Service Bulletin

SUBJECT: Service Update for Inventory Vehicles Only
Engine Piston Casting Error
Expires September 30, 2014

MODELS: 2013-2014 Chevrolet Malibu and Impala Equipped with
4 Cylinder Engine (RPO LCV or LKW)

3613307

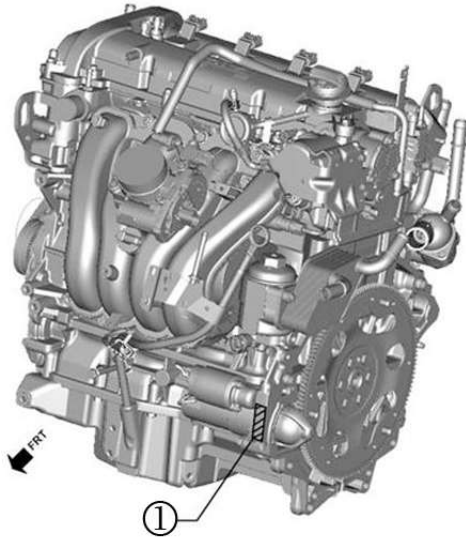
Note: A VIN derivative is required to be permanently engraved on the new engine prior to installation. Refer to the illustration above for VIN engraving location point. VIN derivatives must be formatted as indicated below (# = last eight characters of the VIN).

Chevrolet Malibu: 1J*1#####B

Chevrolet Impala: 1S*1#####B
